TO: Derek Case, PE MS 47354 / 360-705-7826
THRU: Paul Johnson, PE NB82-230 / 206-805-2920
FROM: Andrew P. Walter, PE NB82-230 / 206-805-5452
SUBJECT: 007999 – SR99 Bored Tunnel Alternative Design-Build Project
Federal-Aid No. BR-NH-STP-STPF-0099(111)
CO 203 R1 – PCO 640, SURFACE TEXTURING

Attached for HQ execution is Change Order 203 R1, "PCO 640, SURFACE TEXTURING".

CONTRACT NO: 007999 FEDERAL AID NO: STP-BR-IM-0099 (11)
CONTRACT TITLE: SR 99, BORED TUNNEL ALTERNATIVE - DESIGN BUILD PRO
CHANGE ORDER NO: 203 RI PCO 640, SURFACE TEXTURING

Subject: SR 99 Bored Tunnel Alternative Design-Build Project
Contract No. 007999 / Federal-Aid No. BR-NH-STP-STPF-0099(111)
Request for Change Proposal – Roadway Surface Abrasion

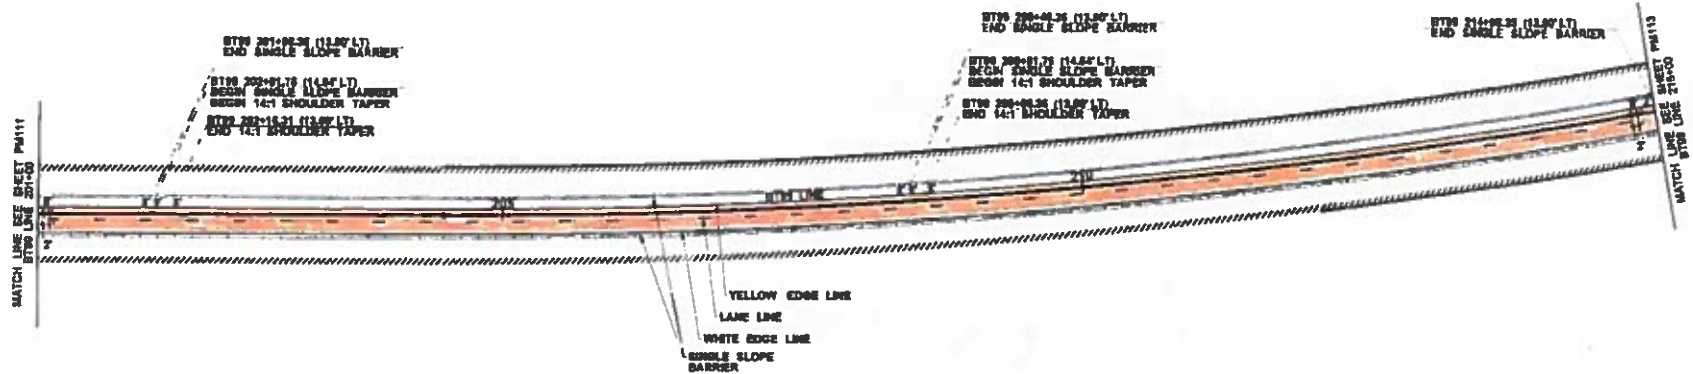
CHANGE PROPOSAL #1, #2, #3
BEGIN TEXTURIZING
S-NB99 182+00

CHANGE PROPOSAL #1, #2, #3
BEGIN TEXTURIZING
S-NBON 3+60

SR 99 TUNNEL PROJECT
 CONTRACT PACKAGE 14
 PAVEMENT MARKING AND
 BARRIER PLANS - NB

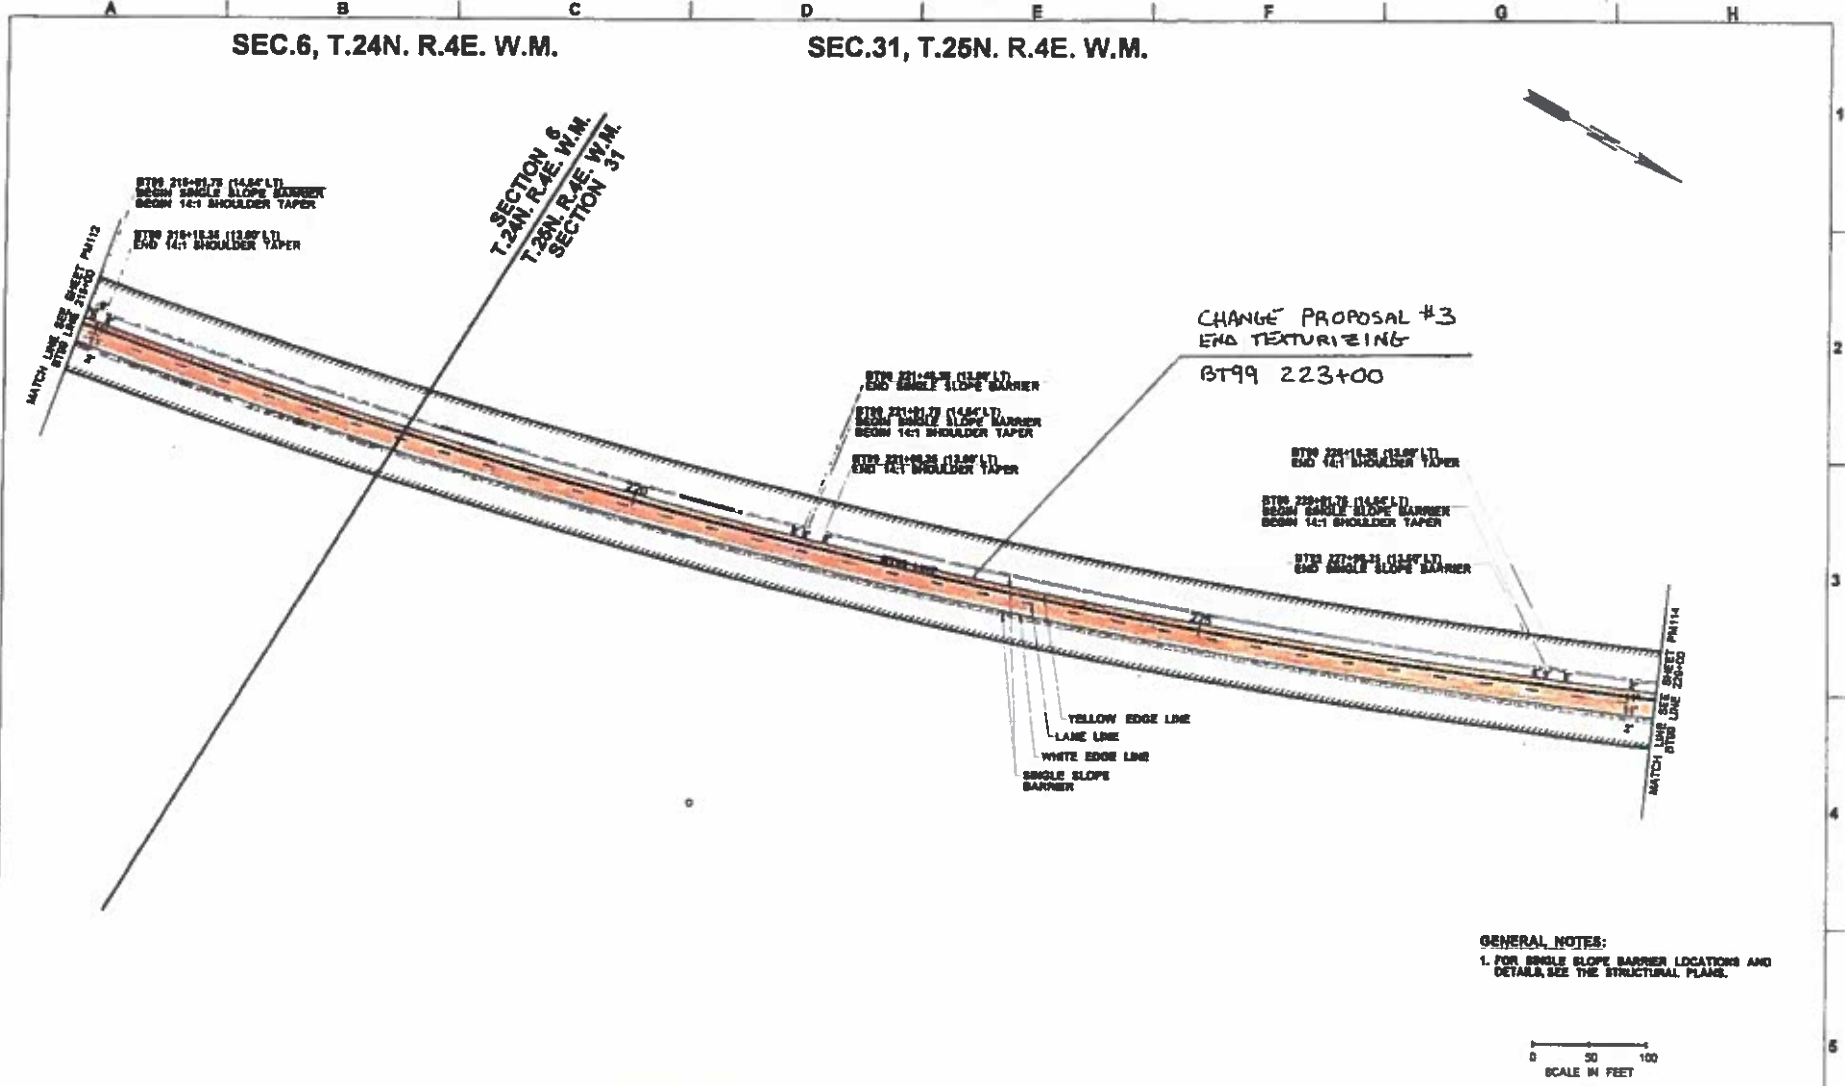
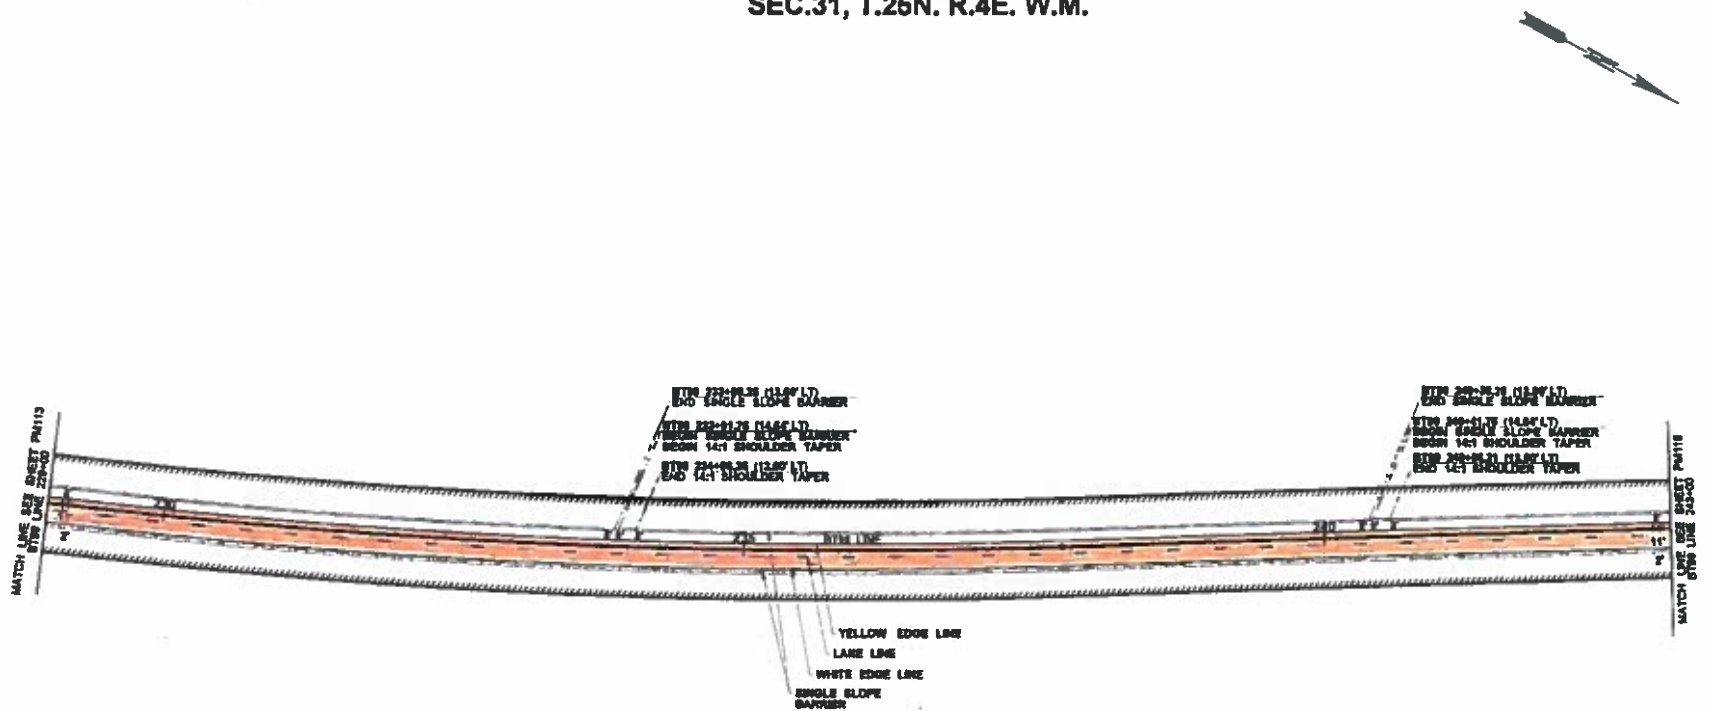
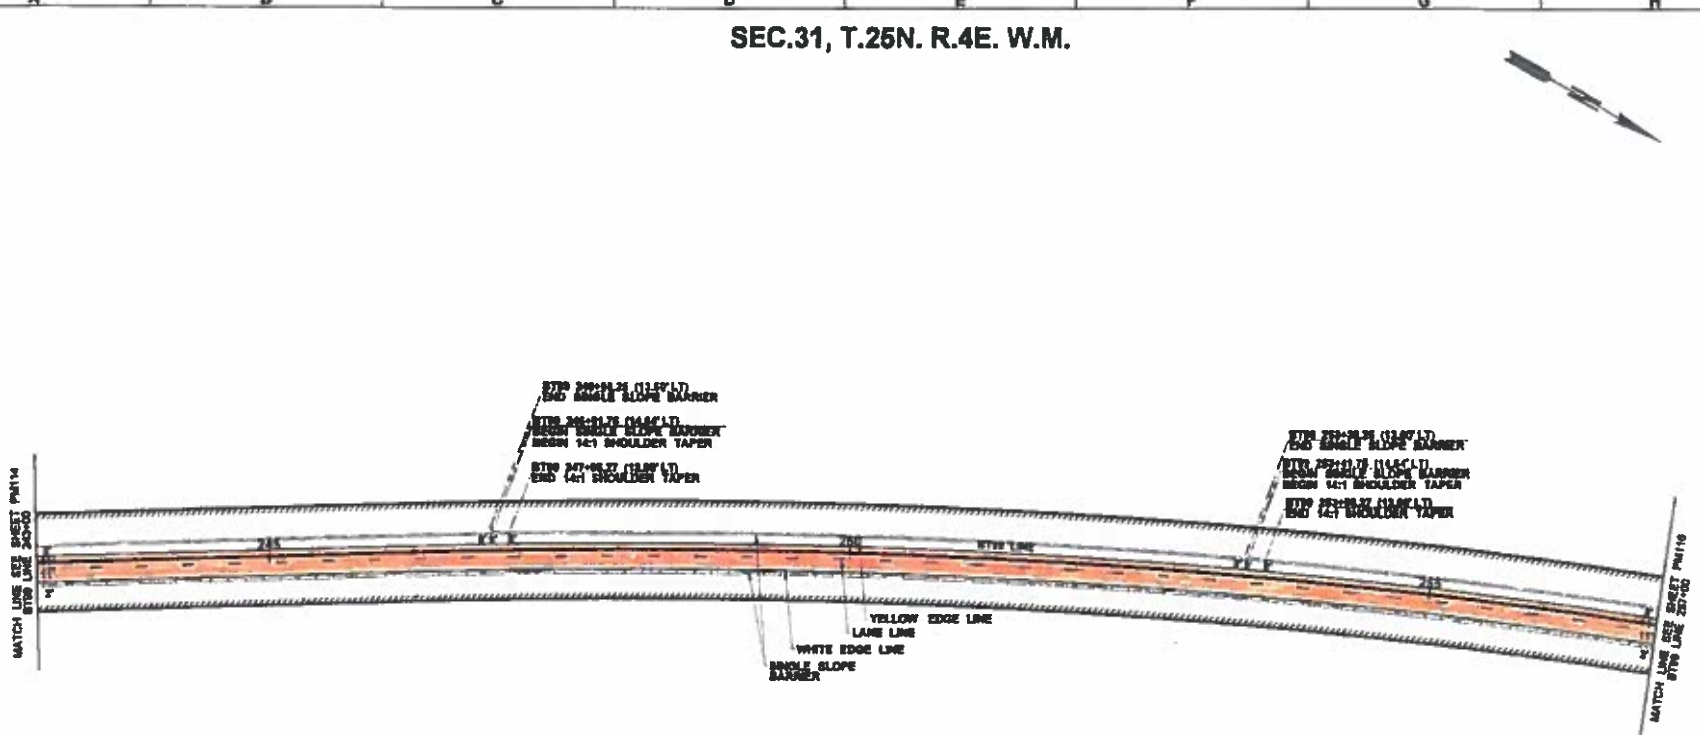
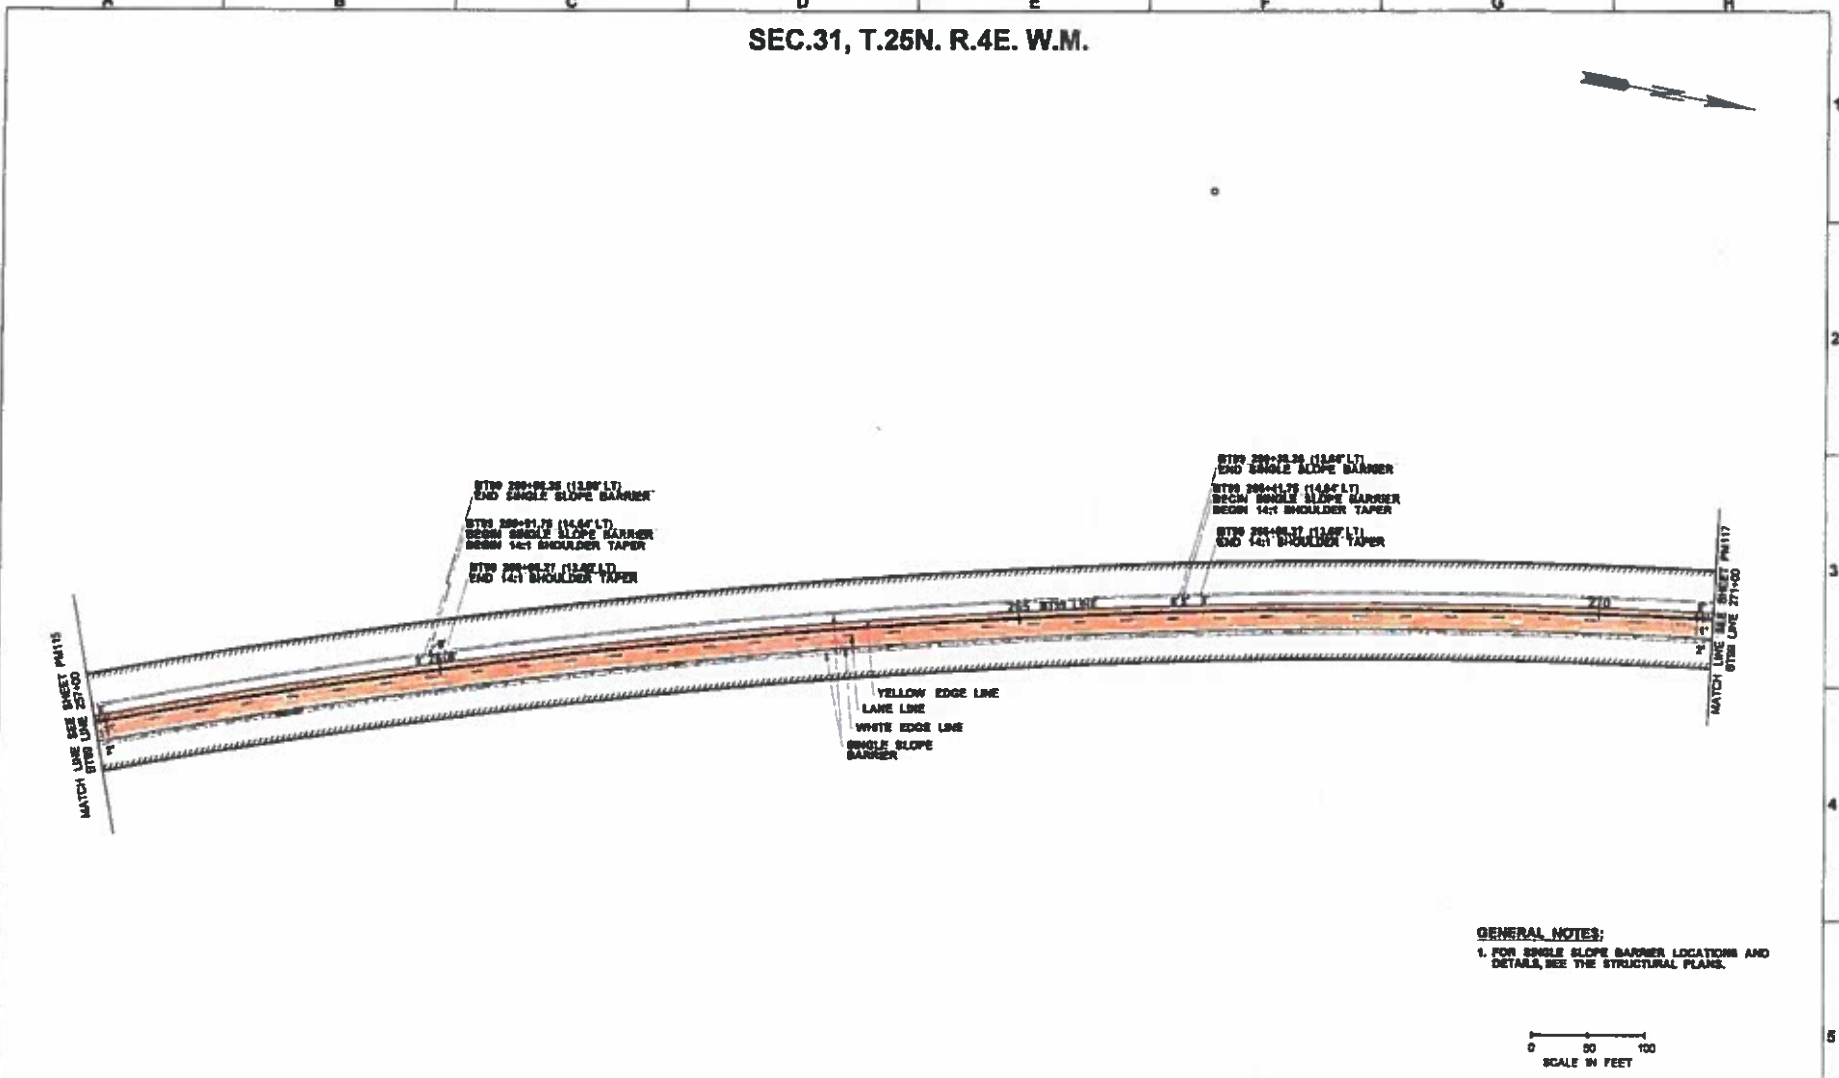
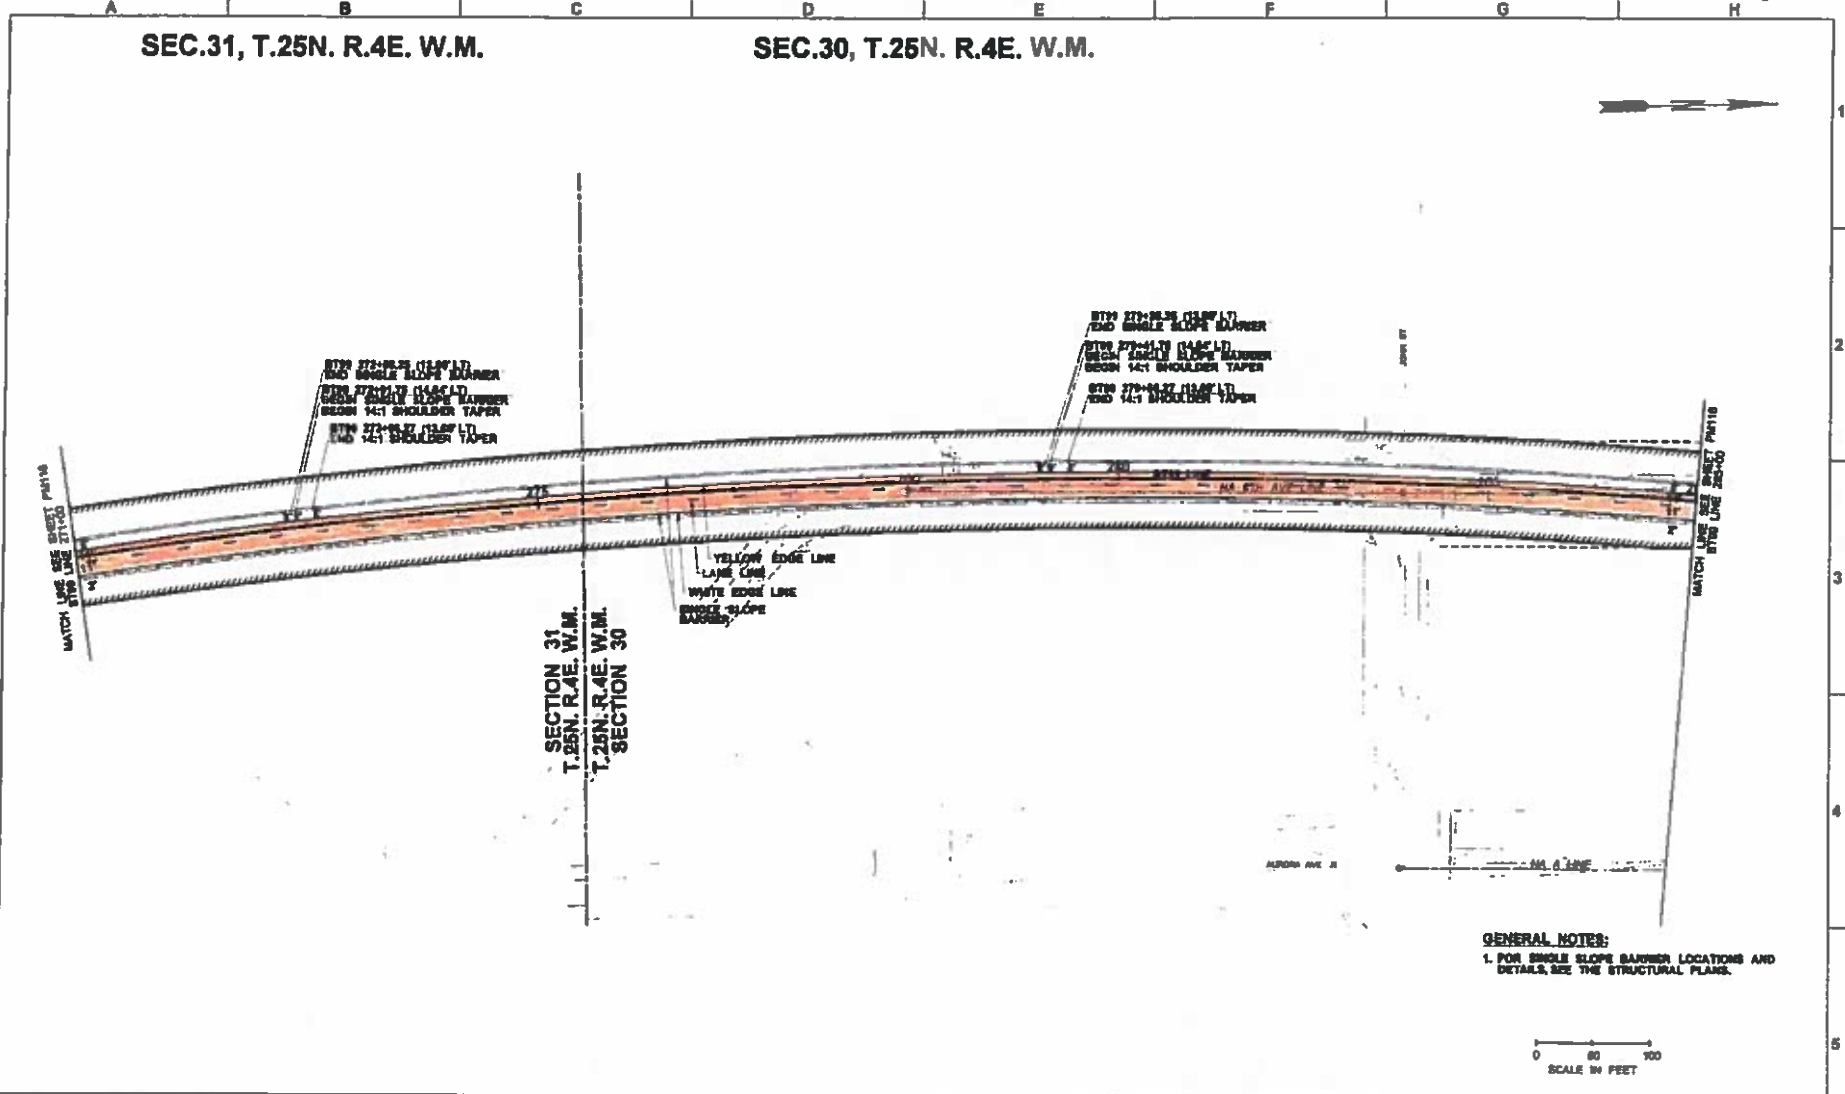
- Texturize two 11-foot lanes, northbound tunnel, portal to portal, stations:
 - S-NB99 STA 182+00 to S-NB99 194+50 (match line with BT99 194+50)
 - S-NBON 3+60 to S-NBON 9+13 (match line S-NB99 187+62.68)

- Northbound roadway BT99 194+50 to BT99 287+23.14 (match line with N-NB99 300+00)
 - N-NB99 300+00 to N-NB99 304+65
 - N-NB99 300+00, begin off ramp taper to N-NB99 304+49.45 end off ramp taper (match line with NBOFF 304+50)

BR 99 TUNNEL PROJECT
CONTRACT PACKAGE 14
PAVEMENT MARKING AND BARRIER PLANS - SB

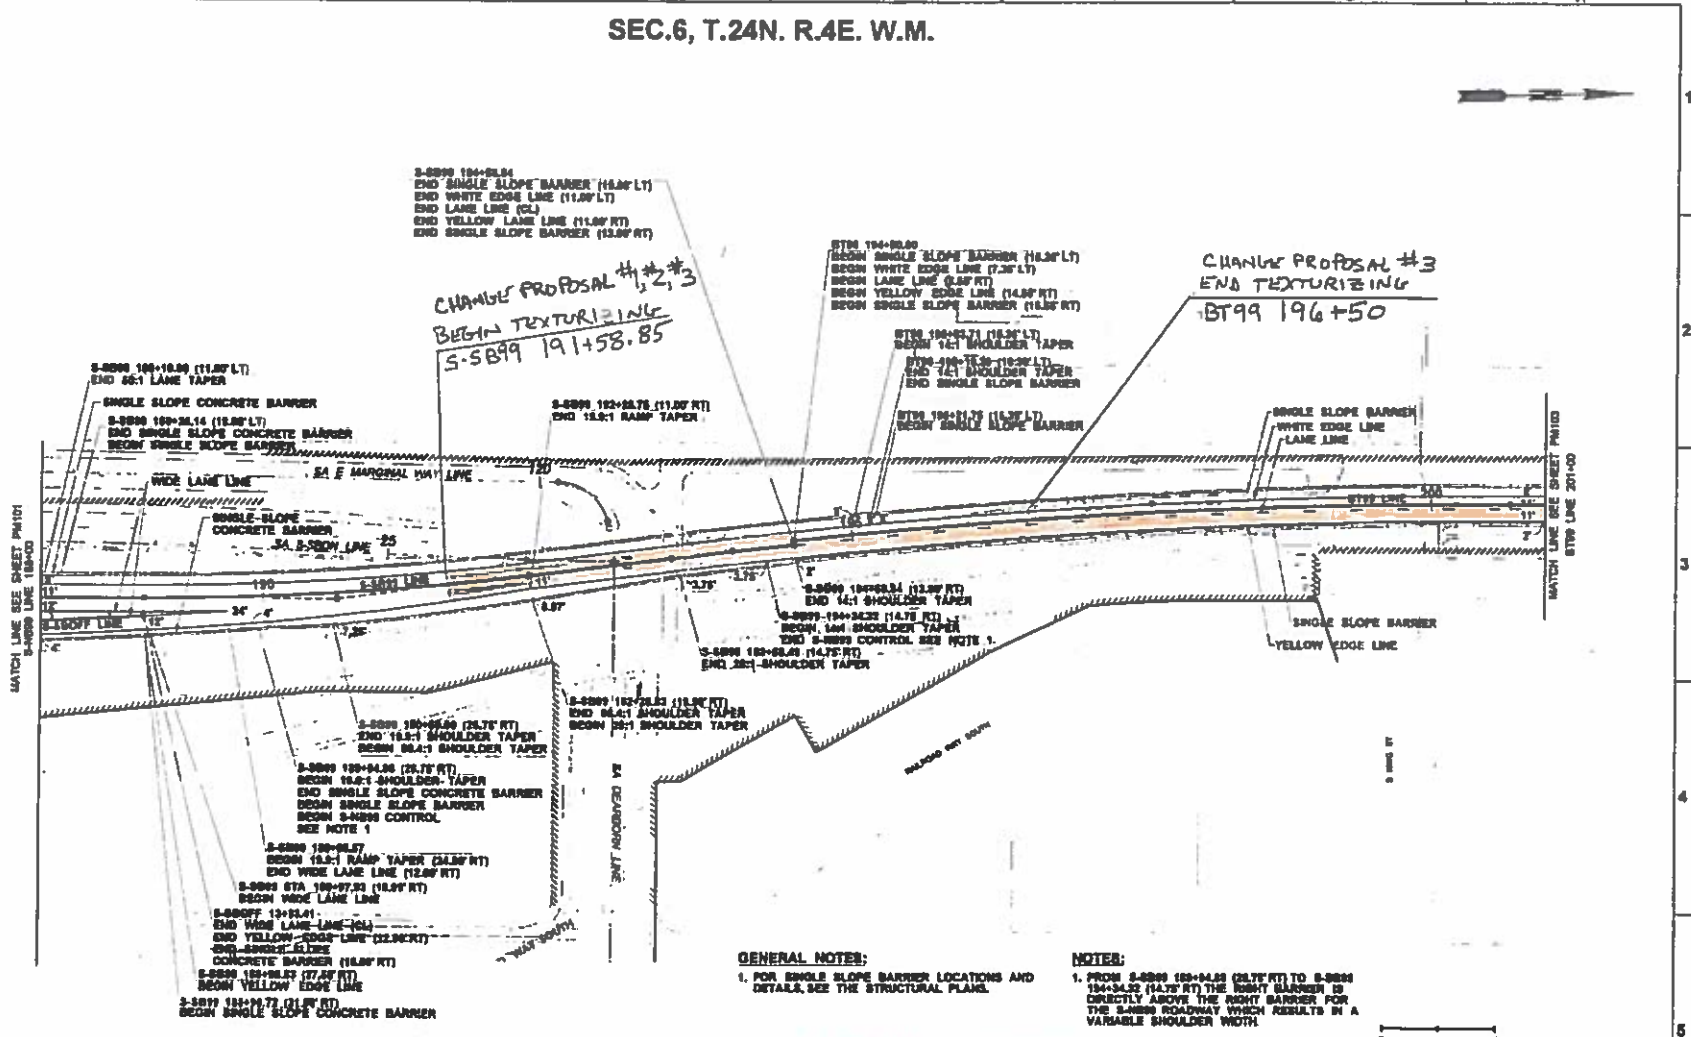
- ① CHANGE PROPOSAL #1 scope includes CHANGE PROPOSAL #2 plus shoulders as described in letter.
- ② See callouts in plans for BEGIN/END taperizing for CHANGE PROPOSALS #1, #2, #3
